PLANNING COMMISSION STAFF REPORT

AGENDA ITEM: Saint Paul Police Training Facility, 2621 Linwood Avenue East
 a) Conditional Use Permit Resolution
 b) Design Review Resolution
 c) Wetland Buffer Variance Resolution

PROJECT: Saint Paul Police Firearms Training Facility
2621 Linwood Avenue

Project: St. Paul Police Training Facility

Attachment: Wetland Buffer Variance_Septic
Variance Site Plan

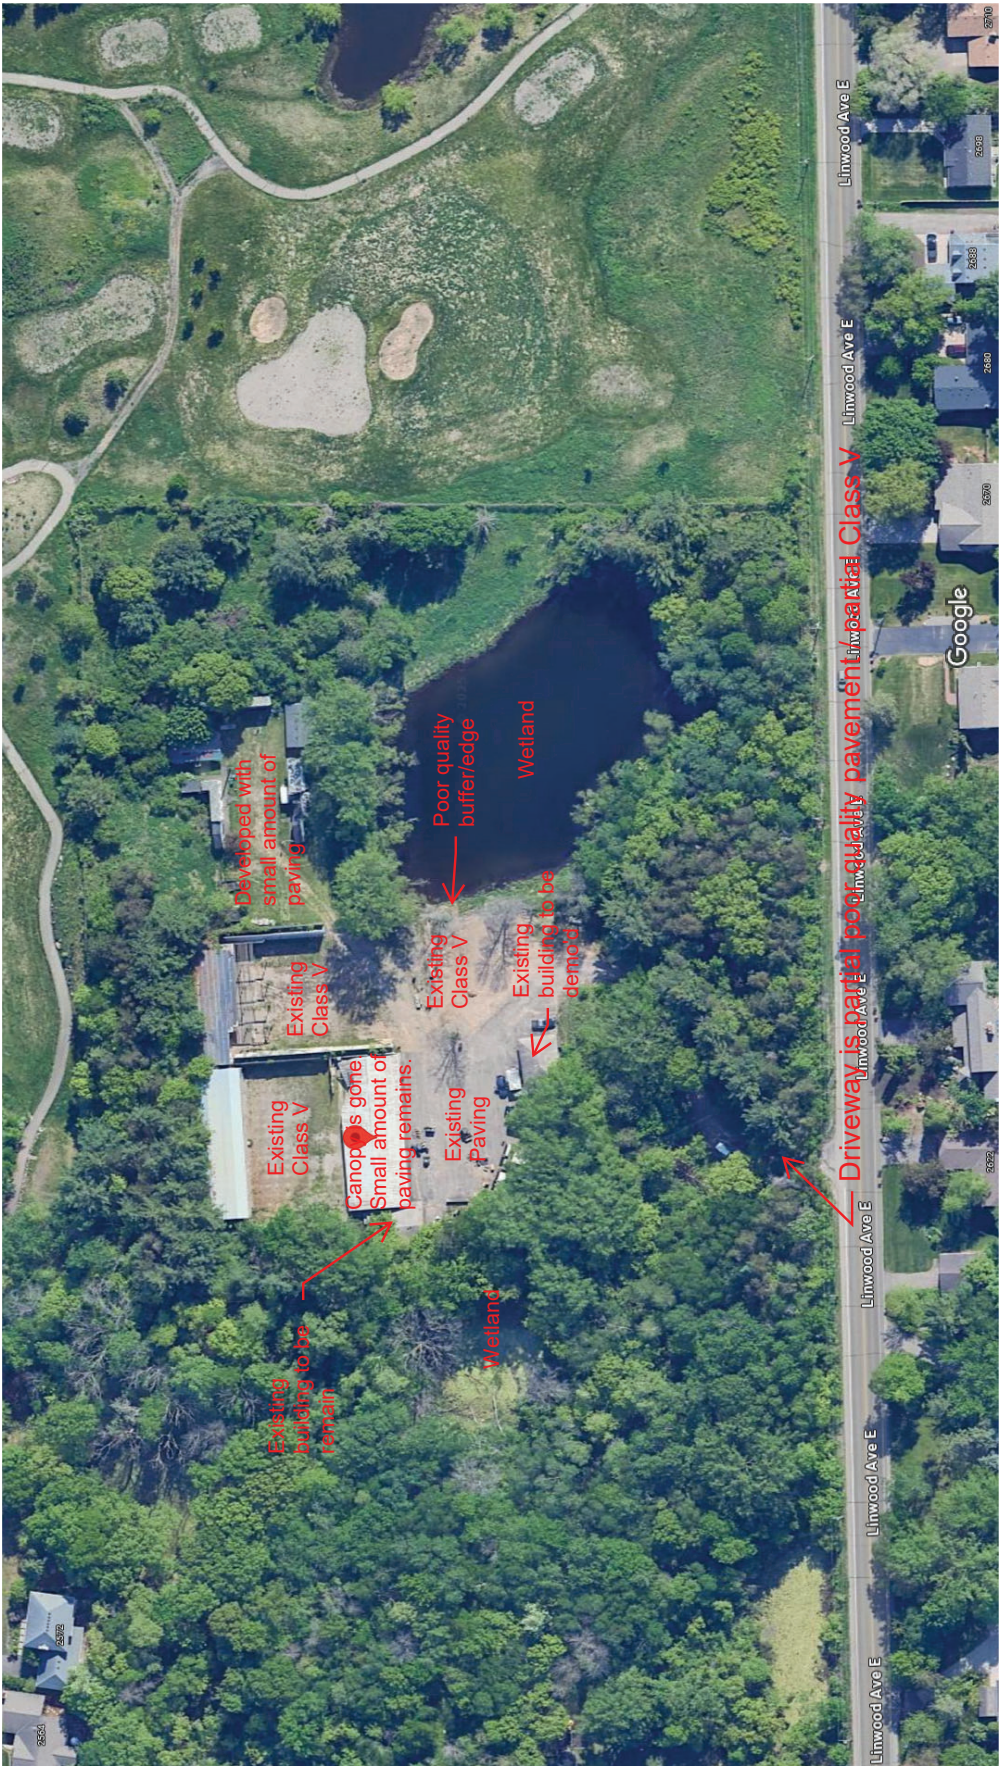
We request the proposed project be approved to encroach into the wetland buffer as shown on the attached site plans. The dimensions of encroachment vary and are dimensioned on the site plan, and summarized here:

Encroachment of grading at west edge of building earthwork:	12' to 16'
Encroachment of septic field:	13'
Encroachment of electrical utility:	21.5'
Encroachment of regrading at existing driveway:	11.5' to 29.5'

Here is a summary of the justification of the placement of the SSTS. The system will infringe on the wetland buffer of 100 feet.

Essential character – The value of the location of the new mound serves as a great place to build a 4.5-foot-tall mound that will be 52.9' wide by 83.4' long. Though the mound will be visible from Linwood Ave, once the grass is established, it will be part of the natural hill landscape and provides an additional barrier from the activities of the Gun Range and neighbors.

LANDSCAPE PLAN

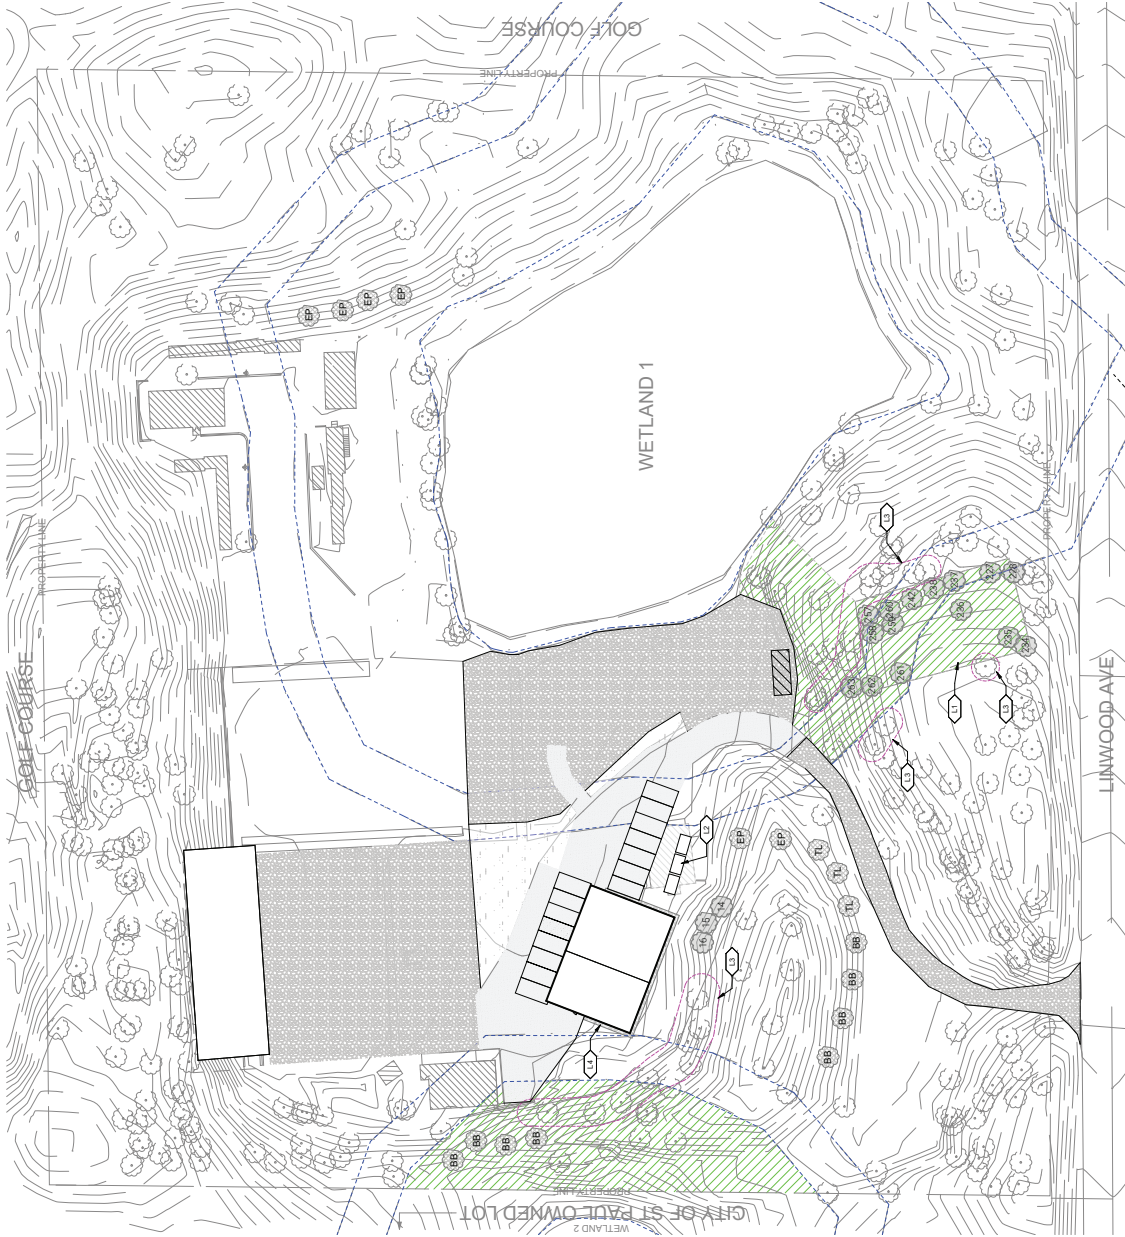
2. Tree Impacts: The tree survey identifies 308 significant trees on the site, however, the overall caliper inches of significant trees are not included. The site demolition plan shows the removal of 18 significant trees, however, the size and species of the trees are not included. Tree replacement cannot be determined without additional information, but it is likely that the tree removal is less than 20 percent of the overall caliper inches of trees on the site. In that case the required tree replacement is 18 – 2 diameter inch trees.

3. Tree Replacement: The landscape plan includes 18 – 2 diameter inch trees.

- a. Prior to issuance of a grading permit the following is required:
 - 1) Tree Plan:
 - a. Identify which trees will be removed on the tree survey and the size and species on the site demolition plan.
 - b. Add the City's tree replacement calculation to the plans. The tree calculation will include the overall caliper inches of significant trees on the site versus the caliper inches of trees removed.
 - 2) Tree Planting Plan: Final tree planting plan to be reviewed and approved by the City's Natural Resources Coordinator.
 - 3) Tree Escrow: Tree escrow in the amount of \$60 per caliper inch of trees to be replaced on the site. The escrow will be released once the trees are planted with a one-year warranty.

- a. Prior to issuance of a grading permit the following is required:
 - 1) Landscape Plan: Detailed plan for buckthorn removal and native seeding. Plan to show seed mix species and seeding installation methods. Final landscape plan to be reviewed and approved by the Natural Resources Coordinator.
